RS-15-255

R. E. Ginna Nuclear Power Plant  
Renewed Facility Operating License No. DPR-18  
NRC Docket No. 50-244

Subject: Response to NRC Audit Review Request for Additional Information Regarding  
Fukushima Lessons Learned - Flood Hazard Reevaluation Report

**Response to NRC Audit Review Request for Additional Information Regarding  
Fukushima Lessons Learned - Flood Hazard Reevaluation Report**

**Figure 9-17: Combined Effect PMF Time Series Plot for Grid Element 3840 – South of Screen House**

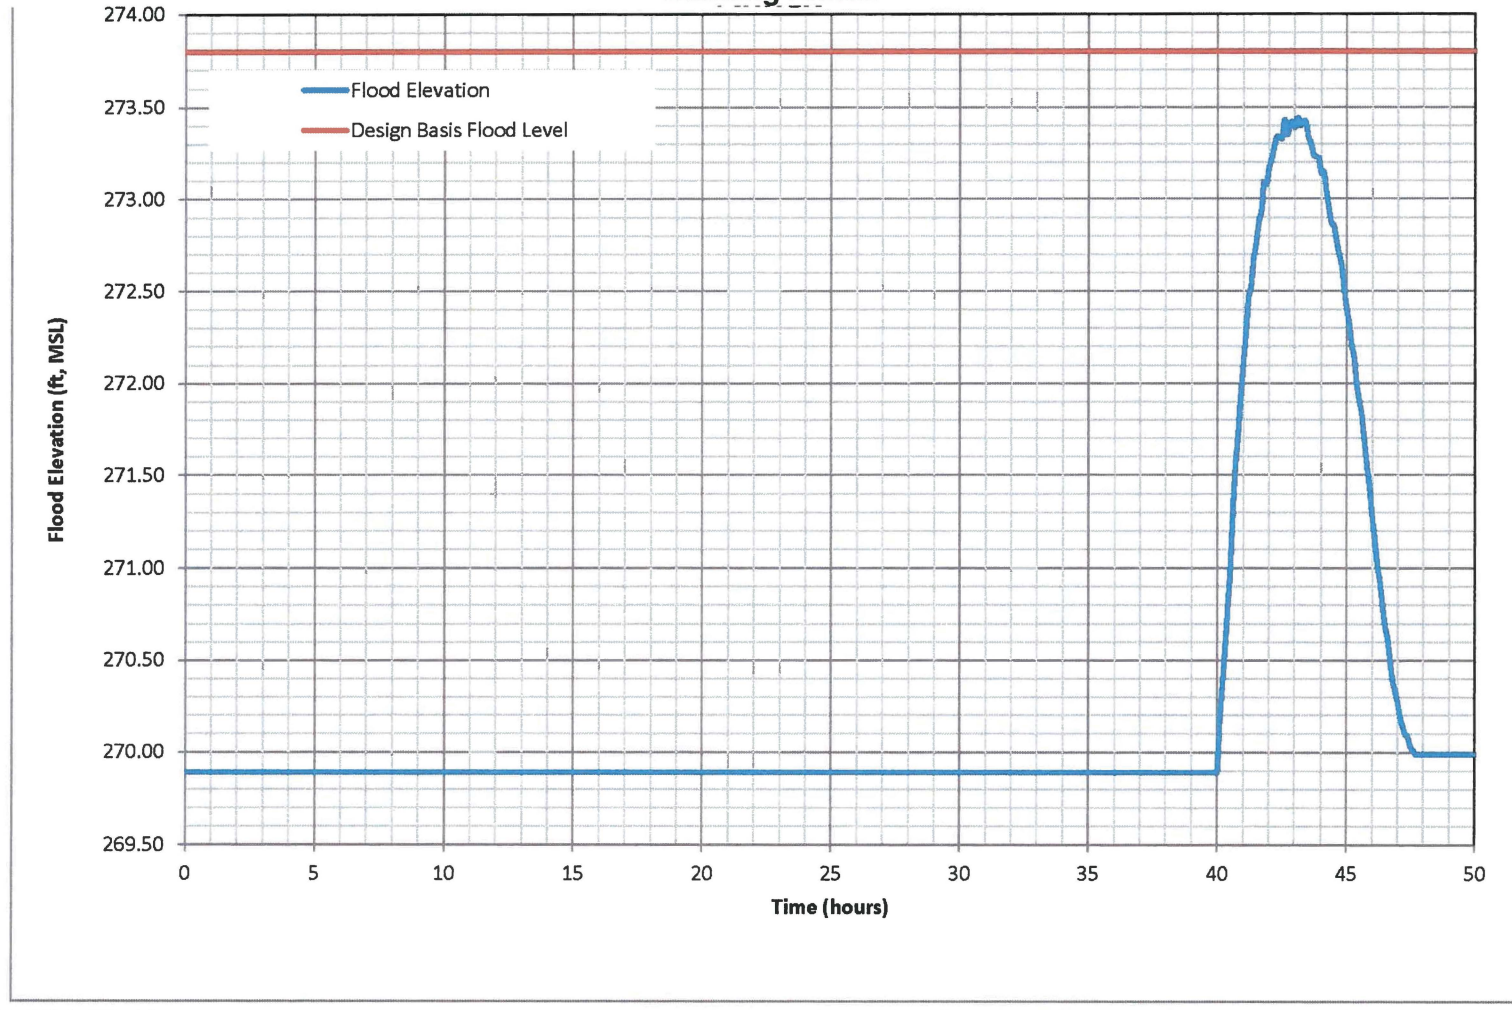
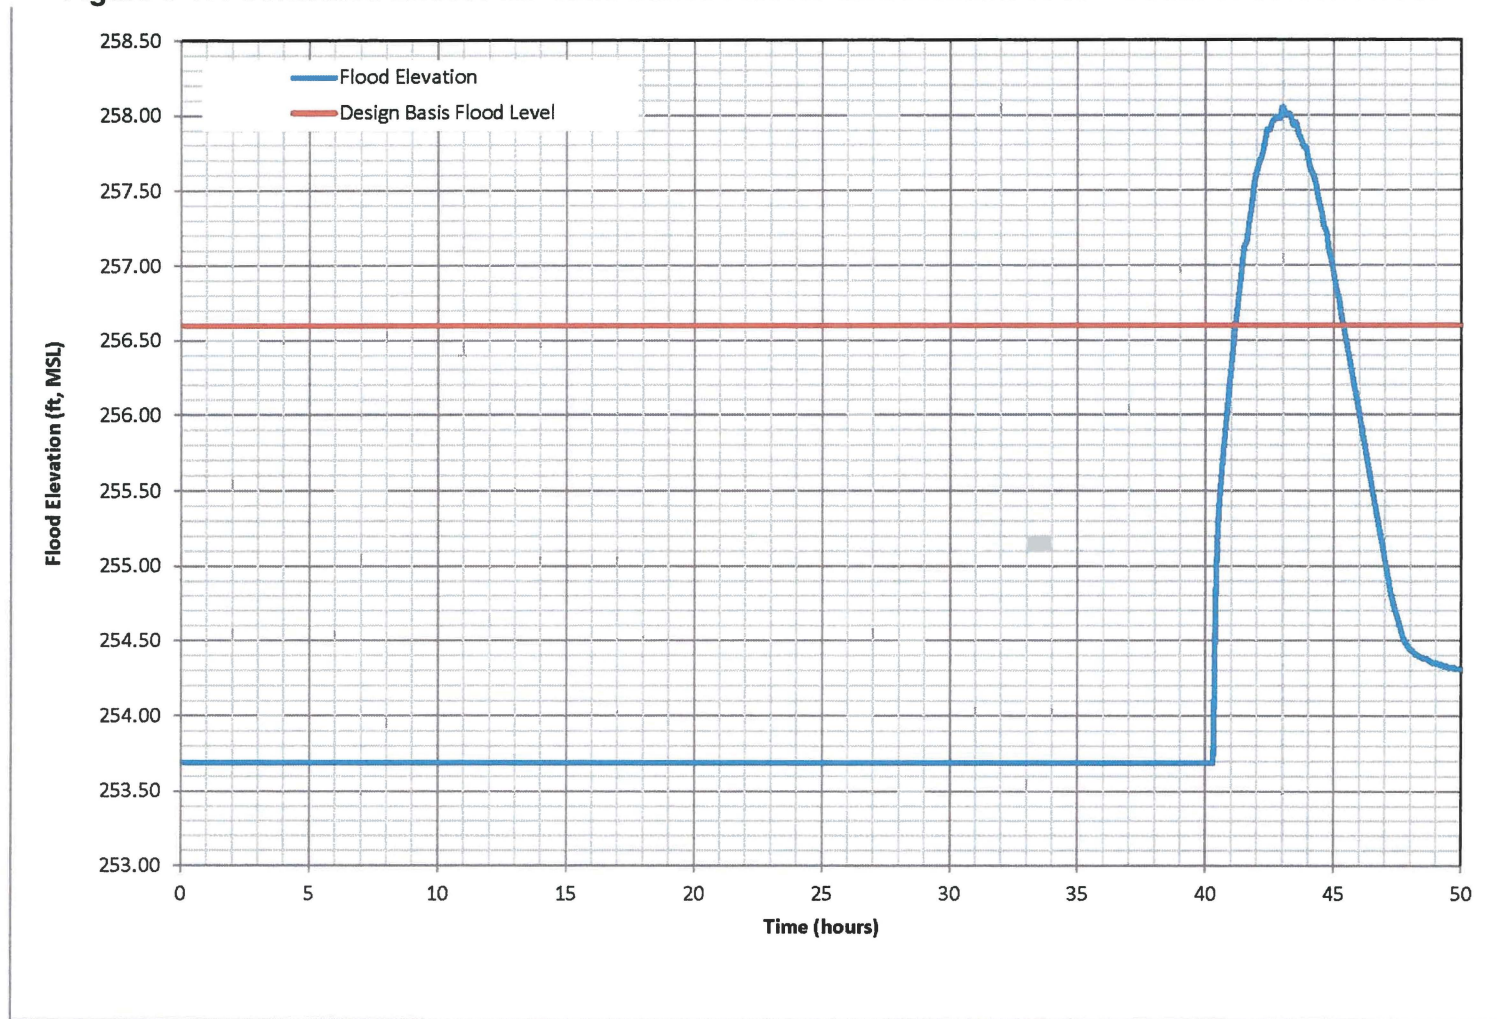
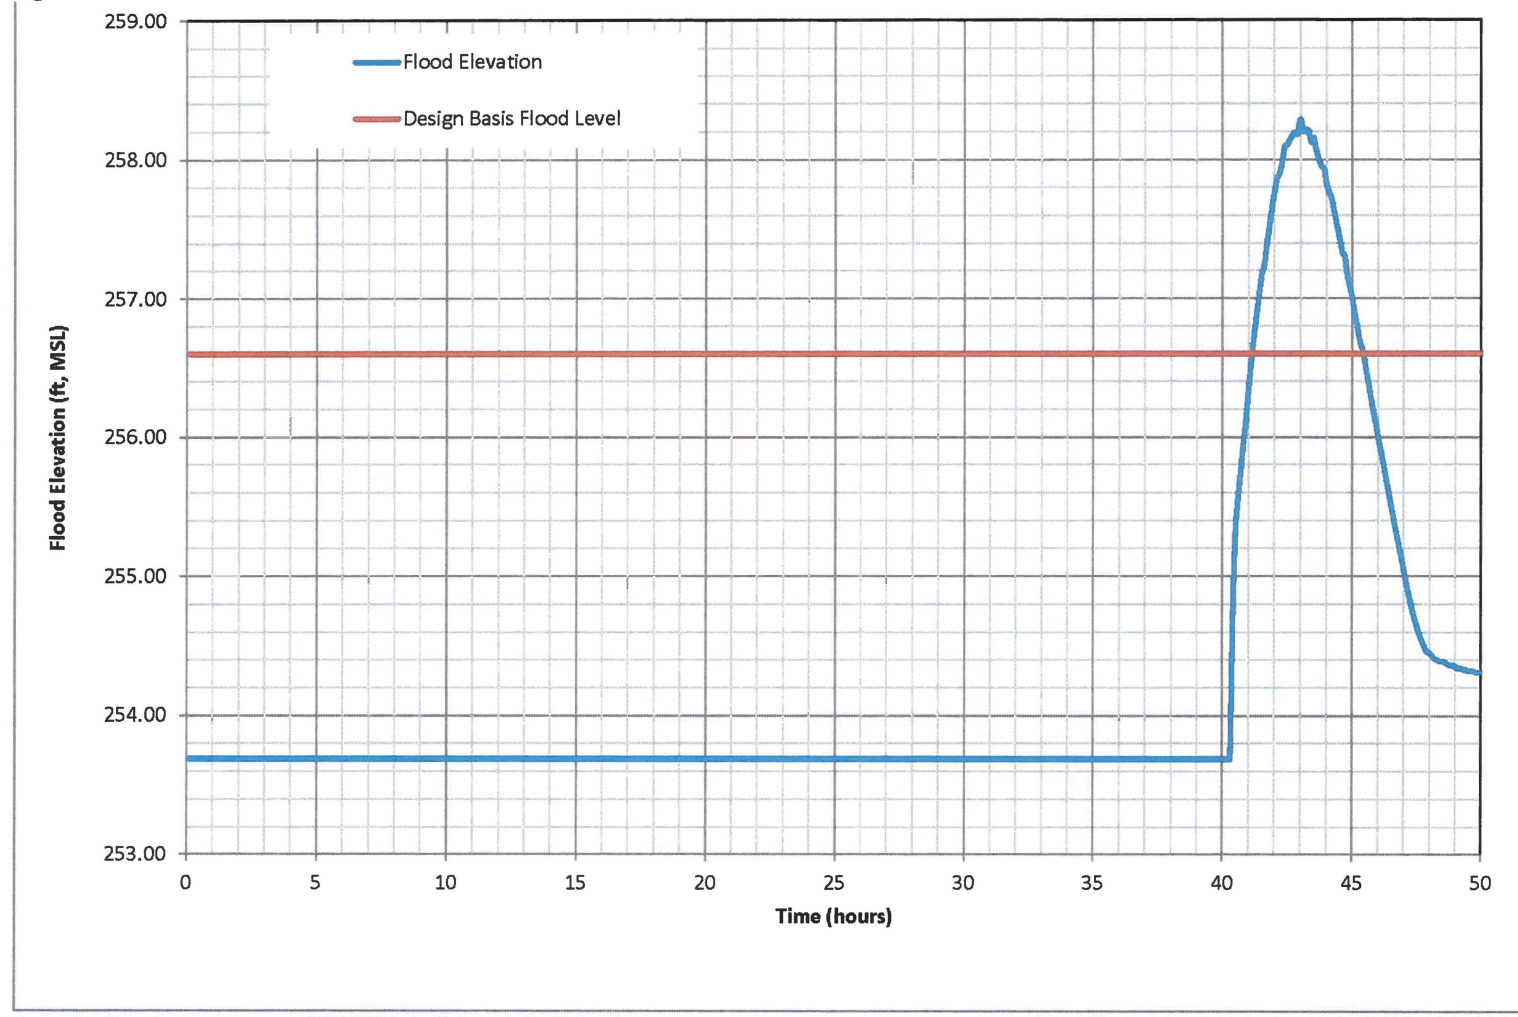
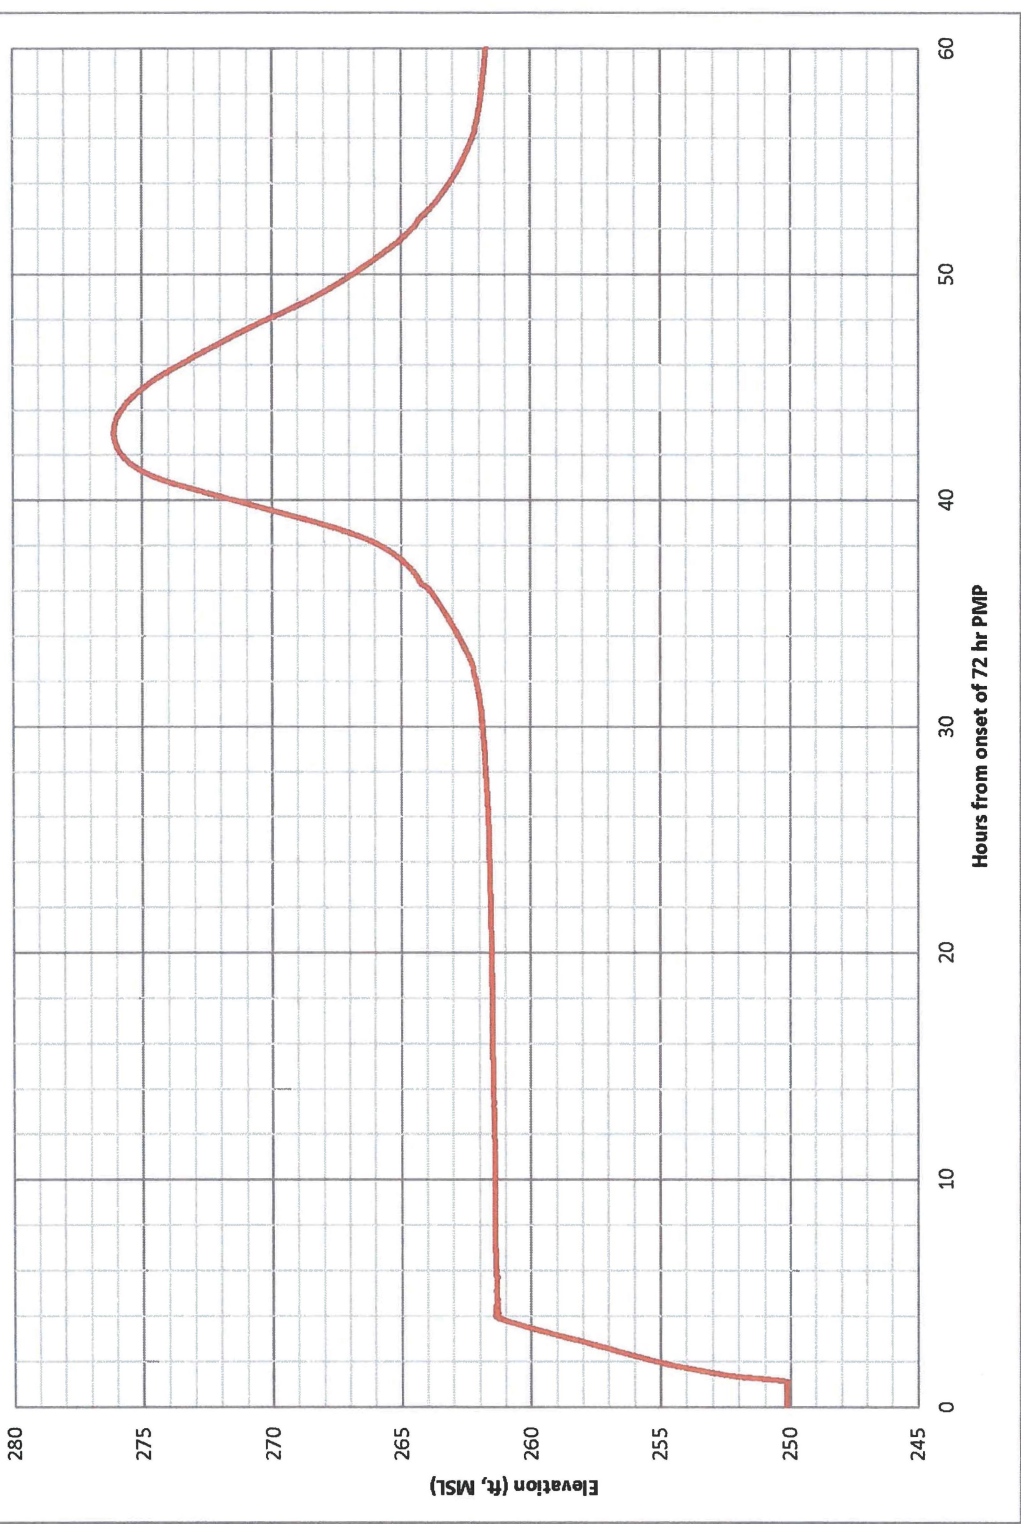
**Request:** *Provide the applicable flood event duration parameters (see definition and Figure 6 of the Guidance for Performing an Integrated Assessment, JLD-ISG-2012-05) associated with mechanisms that trigger an Integrated Assessment using the results of the flood hazard reevaluation. This includes (as applicable) the warning time the site will have to prepare for the event (e.g., the time between notification of an impending flood event and arrival of floodwaters on site) and the period of time the site is inundated for the mechanisms that are not bounded by the current design basis. Provide the basis or source of information for the flood event duration, which may include a description of relevant forecasting methods (e.g., products from local, regional, or national weather forecasting centers) and/or timing information derived from the hazard analysis. The FHRR does state a PMF flood duration (6.5 h) but other parameters are lacking.*

*In Section 3.3 of the FHRR, LIP, flooding on rivers and streams, and two combined-effects flood scenarios were stated to exceed the current licensing basis (which needs to be evaluated/corrected per Information Need #1). The FHRR did not provide sufficiently clear information on all flood duration parameters.*

Time series graphs for the LIP flood mechanism at key locations are provided as Figures 9-1 through 9-9. Time series graphs for the combined effect PMF flood mechanism at key locations are provided as Figures 9-10 through 9-19.

The FHRR indicates flood protection measures described in the FSAR trigger on flood levels at Driveway Bridge. Based on detailed time-series data for the combined effect flood scenario (bounding Deer Creek flooding scenario), there is a 35+ hour delay between the triggering flood levels at Driveway Bridge and flood levels above grade near plant structures.

**Figure 10-1: FLO-2D velocity vectors and peak velocity values (in feet per second) for the PMF combined effect flood.**

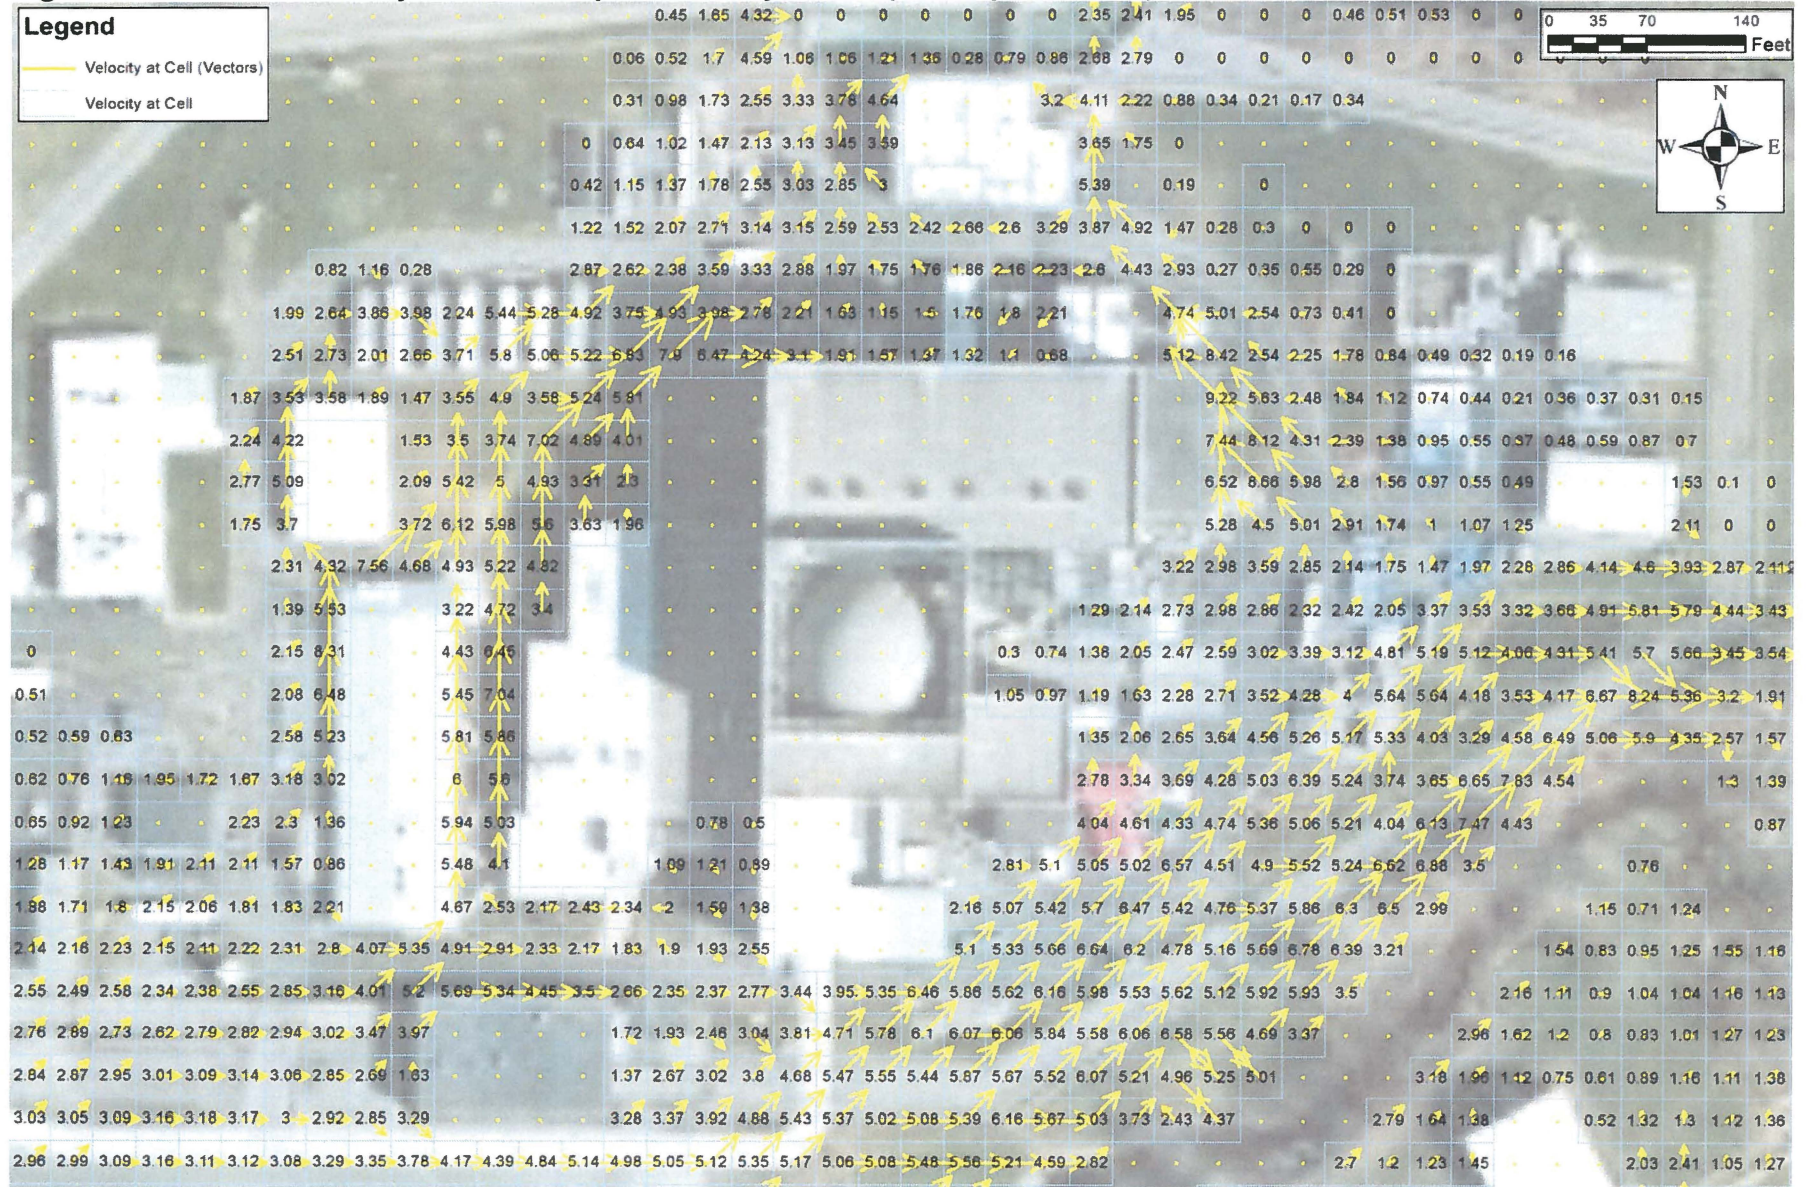
**Request:** Provide the flood height and associated effects (as defined in Section 9 of JLD-ISG-2012-05) that are not described in the FHRR for mechanisms that trigger an Integrated Assessment. This includes the following quantified information for each mechanism (as applicable):

- Wind waves and run up,
- Hydrodynamic loading, including debris,
- Effects caused by sediment deposition and erosion (e.g., flow velocities, scour),
- Concurrent site conditions, including adverse weather,
- Groundwater ingress

Debris loading is not expected to be significant at critical structures due to the resultant shallow maximum flow depths (Table 10-1), limited availability of debris, and distance of the Deer Creek channel to the powerblock area. As shown in Figure 10-1, the predominant flow path of the

PMF is along the Deer Creek channel. Other higher-velocity areas occur along or near site access roads, which have fairly shallow flow depths generally on the order of less than 2 ft (Figure 10-2, reproduced from Figure 2.9-6 of the FHRR). The shallow depths are likely to prevent large debris from being transported to Ginna from the main flow area (i.e., Deer Creek channel).
